**Response to submissions**

Mesa H Proposal

(Revision to Mesa J Iron Ore Development)

Assessment No. 2121

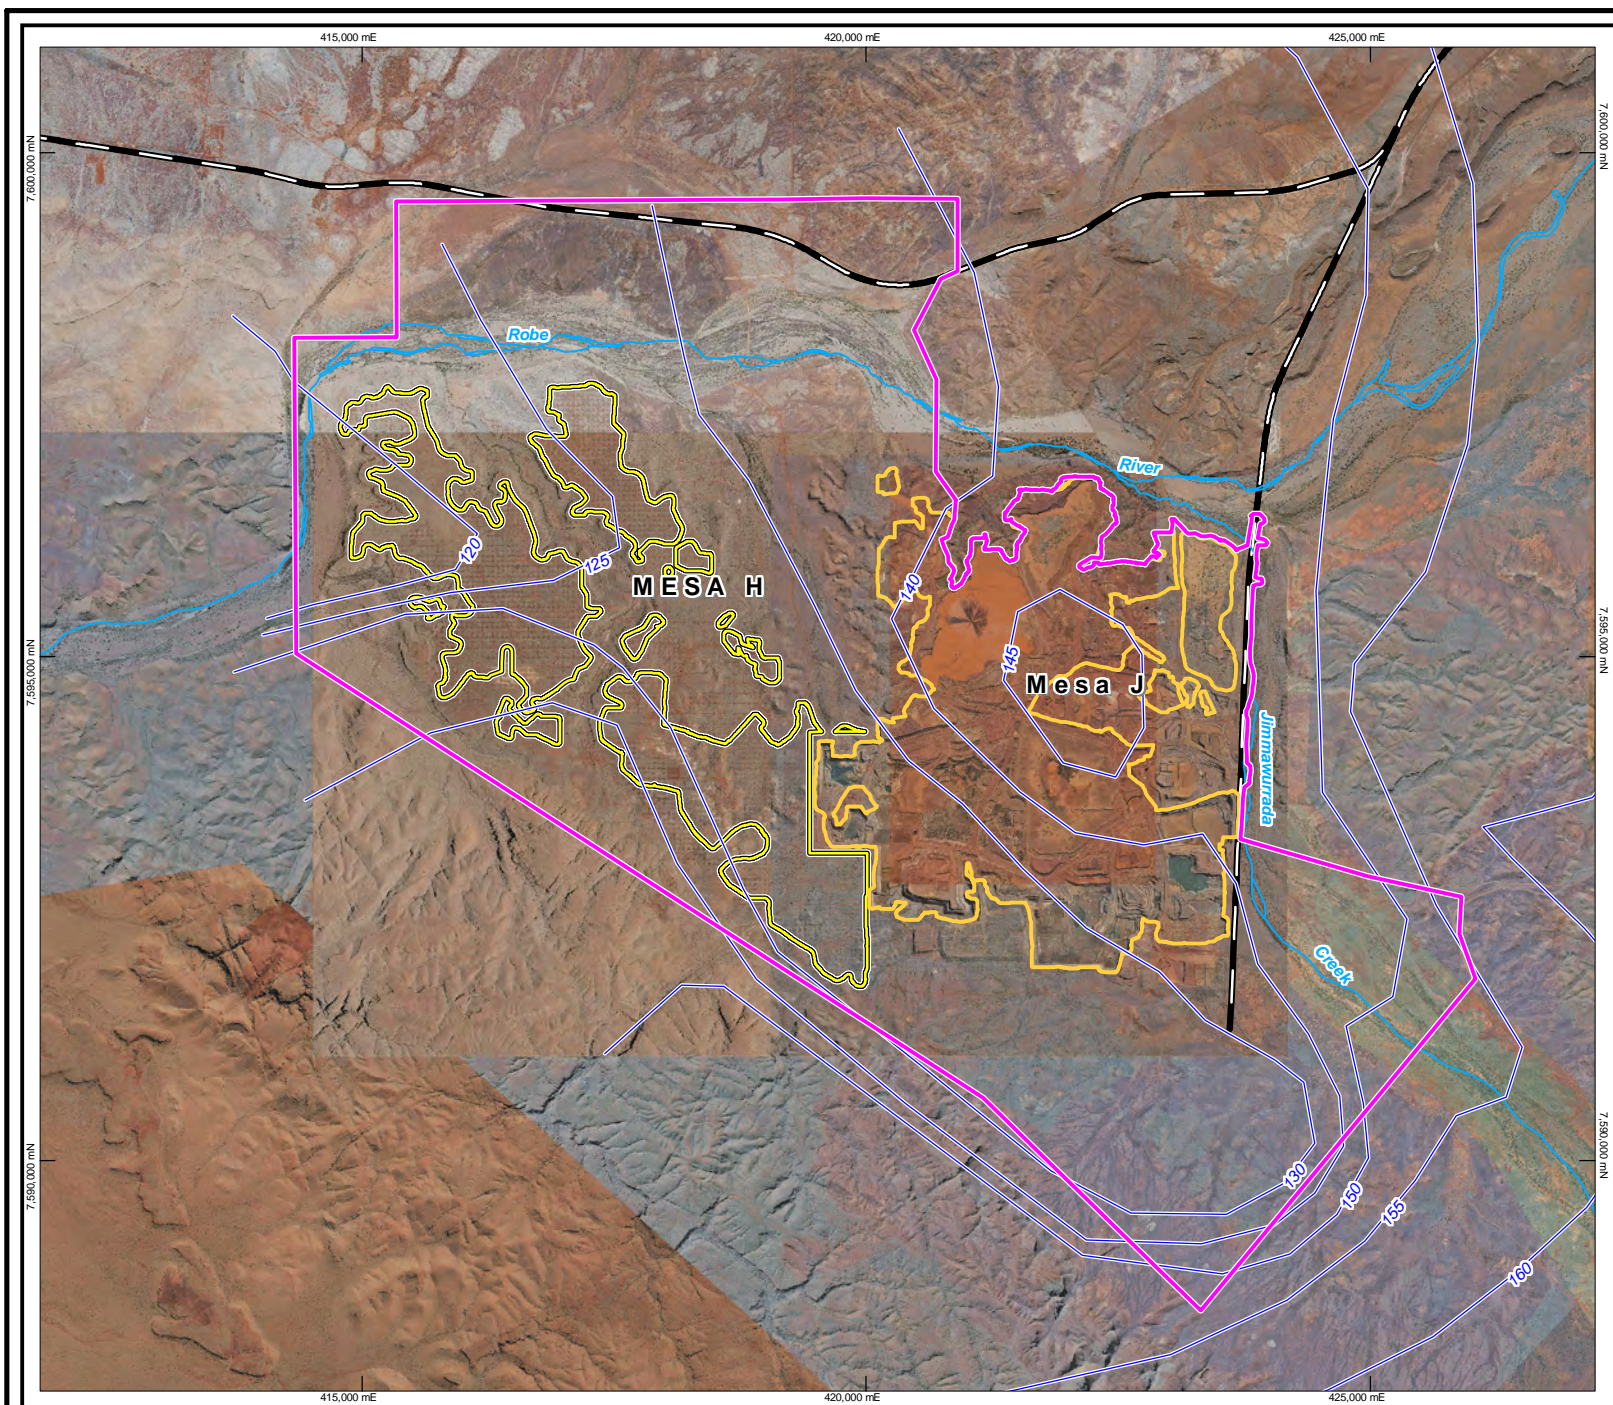
9	DWER	<p><b>A series of separate detailed maps demarcating significant vegetation and significant flora in different drawdown zones should be provided. Areas of significant vegetation to be affected in each drawdown zone should also be provided in a tabular form.</b></p>	<p><b>Noted – new maps provided.</b></p> <p>Mapped riverine areas potentially affected by the Revised Proposal are presented in Table 6-9 of the ERD. Vegetation mapping, including riparian areas, is presented in the ERD in Figure 6-3 (Overview and Maps 1-3). Further detailed mapping of the riparian zones is presented in Figure 6-5 which provides context regarding overall riparian vegetation significance, and detailed riparian mapping is presented Figure 6-6 (Overview and Maps 1-3).</p> <p>Additional detailed quantitative estimations of riparian vegetation (including significance of the vegetation) in groundwater drawdown zones for Jimmawurrada Creek are presented in tabular form in Table 6-19, and descriptions of impacts presented in Table 6-20. Quantitative estimations for the Robe River are provided in Table 6-21 and qualitative descriptors are provided in Table 6-22. A new map, Figure 1, illustrates significant vegetation including significant riparian communities relative to the modelled groundwater drawdown zones.</p>

No.	Submitter	Submission and/or issue	Response to comment
			<p>A new map (Figure 3, Attachment 1) has been created which displays significant flora species in relation to areas predicted to be subject to groundwater drawdown. The water table at the Mesa H Landform is currently &gt; 20m deep and hence groundwater is currently not within the root zone of significant flora species located on top of, or along the margins of the Mesa landform.</p> <p>Flora species in the mapped riparian zone of Jimmawurrada Creek comprise sparse numbers of Priority 3 flora: <i>Triodia pisolitica</i> which were surveyed in 2016 when water table levels were ~4 mbgl. Given depth of the groundwater at the time of surveying and that the majority of records of this species occur along the Mesa landform margins, it unlikely that their presence is specifically related to, or likely to be affected by regional groundwater levels; the distribution of this species does not show any degree of correlation to patterns of groundwater depth across rocky habitats it occupies. These species are classified as xerophytes or vadophytes and are plastic in their water use, including opportunistically utilising small fractured rock aquifer sources.</p> <p>Flora species in the Robe River riparian zone comprise the Priority 4 Species: <i>Rhynchosia bungarensis</i>. The predicted peak groundwater drawdown in the Robe River is &lt; 1 m, which is well within the natural levels of seasonal groundwater fluctuation (~2 - 3m) experienced in the Robe River. Whilst it is possible that population numbers may be reduced during extended dry periods or during maximum groundwater drawdown, their presence is still expected to persist. Whilst this species occurs in riverine and creek habitats it is not known to be restricted to shallow groundwater sections of these habitats.</p>

**Figure 2**  
**Current**  
**Groundwater**  
**levels**  
**September 2019**

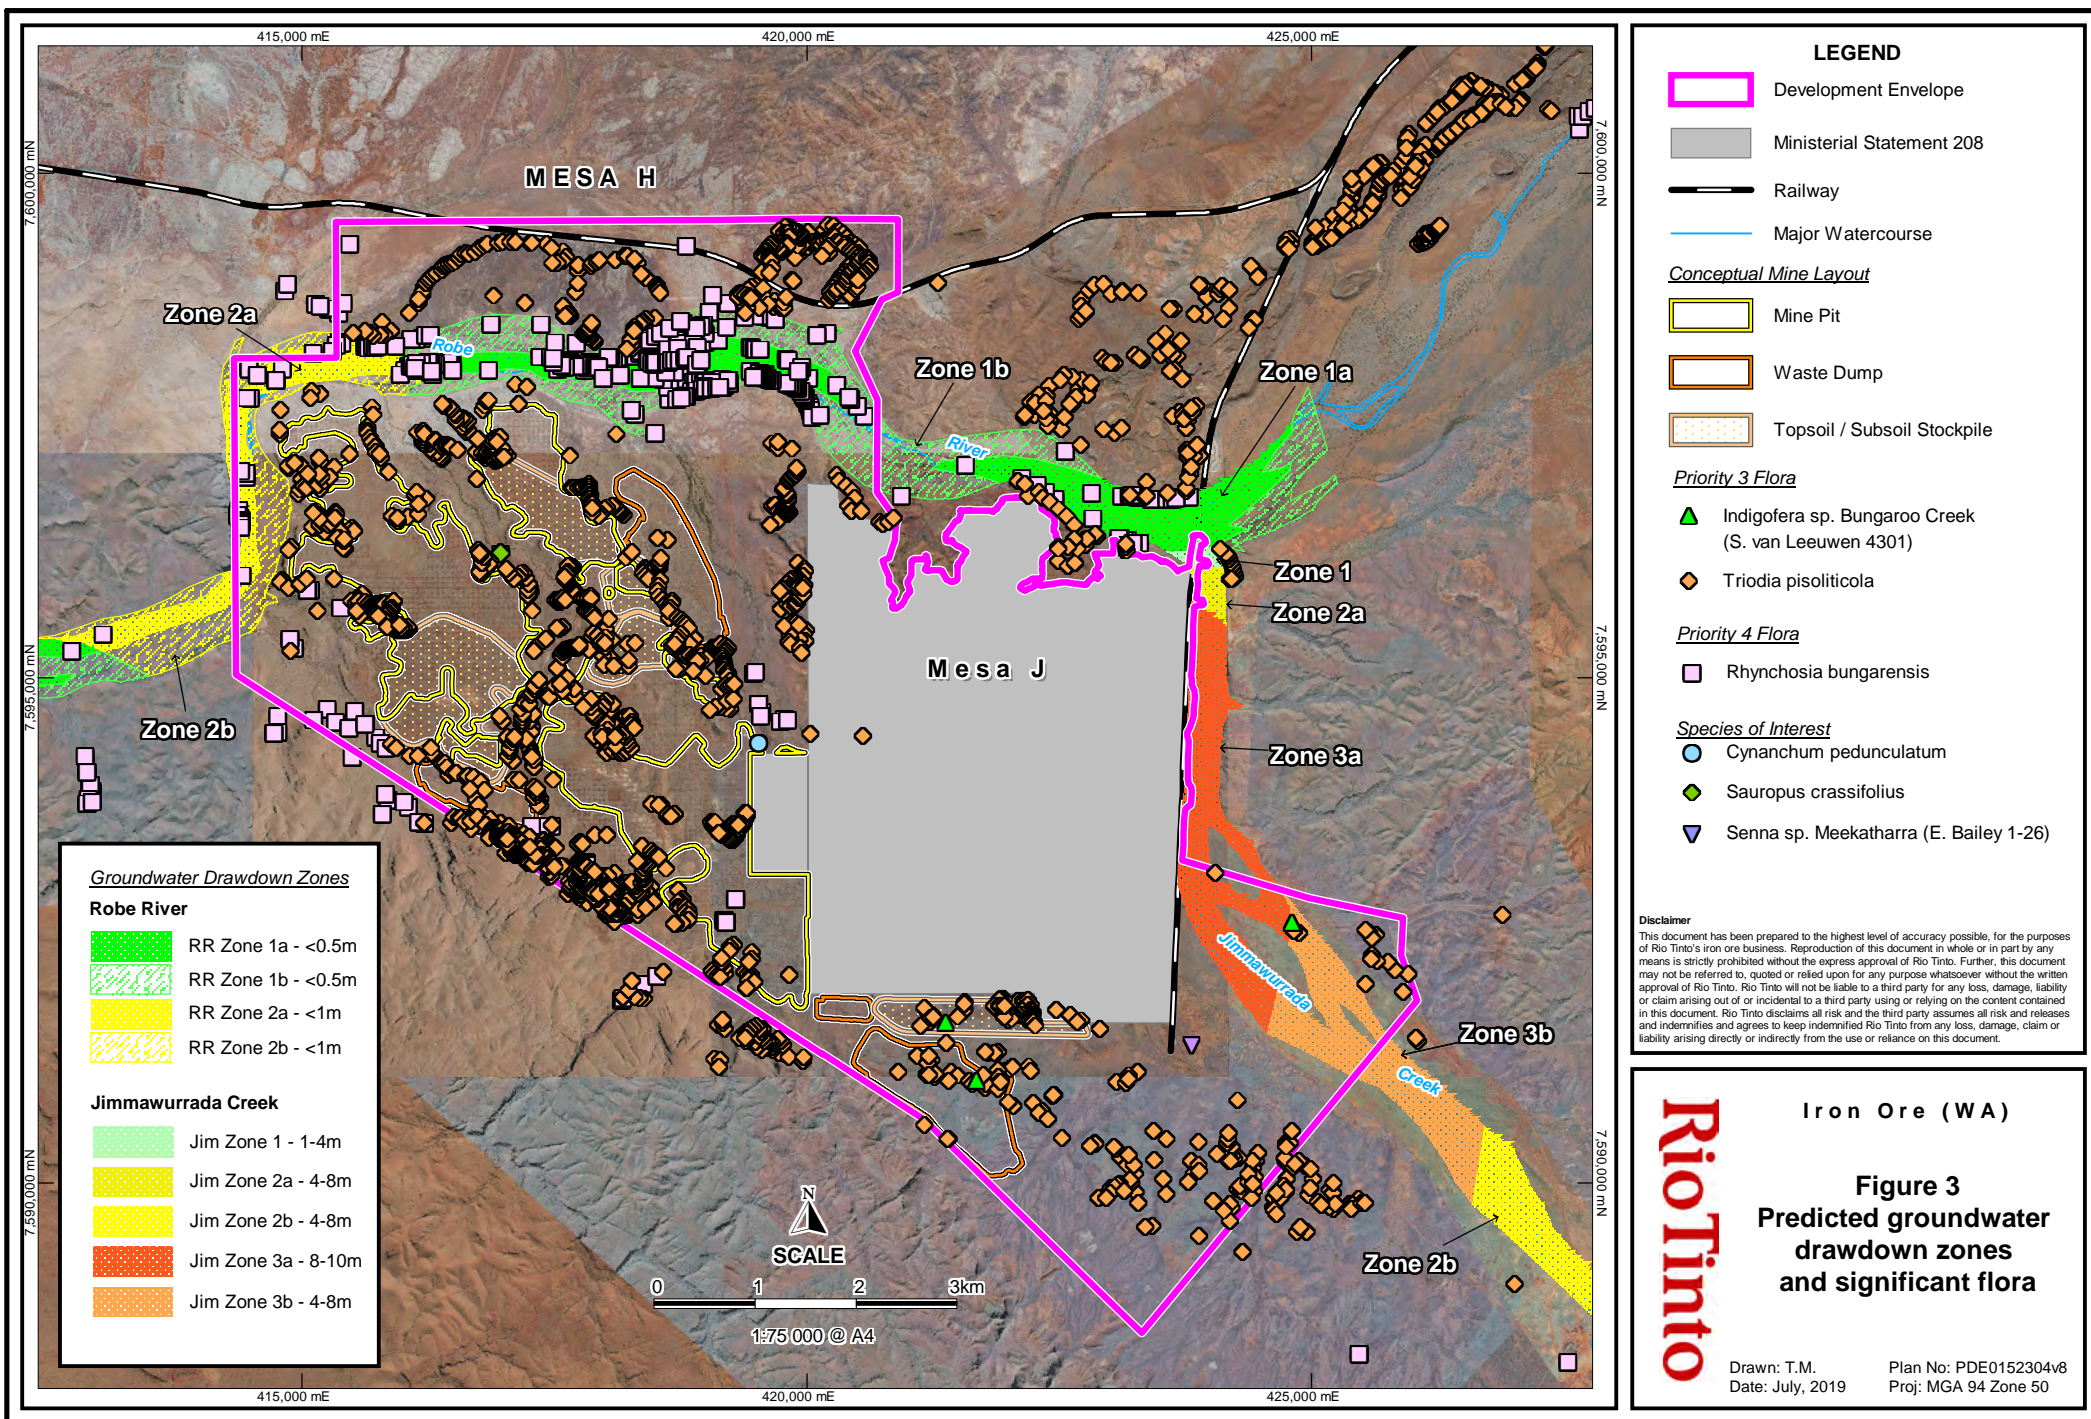
No.	Submitter	Submission and/or issue	Response to comment
2	DWER	<p><b>Detailed maps should be provided for Jimmawurrada Creek indicating current impacts from Mesa J (including impacts from the Southern Cutback Borefield).</b></p>	<p><b>Noted – additional information provided</b></p> <p>A new figure is provided in Attachment 1 (Figure 2) which shows the current groundwater levels in the Development Envelope and immediate surrounds as a result of the extended dry period and groundwater abstraction for Mesa J and the Coastal Water Supply Project (CWSP) operations.</p> <p>Limited historical quantitative vegetation monitoring or detailed long-term baseline information is available for Jimmawurrada Creek in the immediate vicinity of Mesa J to enable accurate differentiation between various stressors and augmentation, including groundwater drawdown, periodic discharge, and natural climatic variables. Quantitative riparian vegetation monitoring has been undertaken further upstream in Jimmawurrada Creek and Bungaroo Creek since 2012, as part of the Coastal Water Supply Project.</p> <p>However, riparian vegetation health information is available in the form of detailed riparian vegetation mapping which provides a snapshot of the current baseline. The riparian vegetation mapping, and an assessment of the current condition of the riparian vegetation along Jimmawurrada Creek is provided in Astron (2016a &amp; 2016b) and Rio Tinto (2018a) which were included in Appendix 9 of the ERD.</p> <p>In addition, further baseline monitoring of wet and dry season riparian survey transects, combined with Leaf Water Potential measurements have been undertaken biannually by Astron since 2016 along both Jimmawurrada Creek and the Robe River to provide a current baseline of the health of the riparian systems, within the modelled extent of the groundwater drawdown associated with the Revised Proposal (Astron 2016c, 2018c).</p> <p>Results indicate that crown condition scores for groundwater dependent tree species have remained relatively stable over time since the Astron monitoring commenced 2016. Leaf water potential of trees at two sites (MHT23w and MHT24w) of the four monitored for water status along Jimmawurrada Creek were noticeably lower (indicating stress) in 2018 compared to 2017; this was believed to be a result of the protracted dry</p>

No.	Submitter	Submission and/or issue	Response to comment
			<p>period, combined with cumulative groundwater drawdown associated with the Mesa J and CWSP operations leading up to the 2018 sampling period.</p> <p>Remote sensing of the entire monitoring area indicated a general decline in the condition of groundwater dependent vegetation canopy potentially as a result of the combined dry conditions and cumulative groundwater abstraction leading up to 2018.</p>
3	DWER	<p>The magnitude of drawdown on the Robe River is predicted to be 0.5-1m and temporary.</p> <p><b>The term temporary should be defined and a timeframe should be provided as part of these predictions.</b></p>	<p><b>Noted – clarification provided</b></p> <p>Groundwater drawdown as a result of mining activities is predicted to be less than 1 m in the Robe River at the peak of dewatering (worst case scenario modelled uncertainty run #2; Rio Tinto 2019). The localised and temporary peak drawdown period is mostly associated with the mining of Mesa H Pit 7 below 120 mRL (below the alluvium water level in the Robe River). Peak groundwater abstraction from Mesa H of approximately 3 GL/a (~7.1 ML/day) is estimated to occur several years later in the mine life (current estimate around 2033 – 2034), which, based on the model, does not translate to additional water level decline in the Robe River alluvium. Following cessation of dewatering in Pit 7 and backfilling, the recovery of water levels in the pools will be dependent on rainfall and stream flows. Furthermore, the first major rainfall event is expected to fully recharge the Robe River alluvial aquifer and seep into the adjacent CID aquifer to gradually recharge the CID aquifer.</p> <p>In the Robe Valley, statistically “small” streamflow events typically occur 1 in 2 years, whilst larger events typically occur 1 in 5 years. Therefore, peak drawdown is expected to last a minimum of 2 and maximum of 5 years.</p>
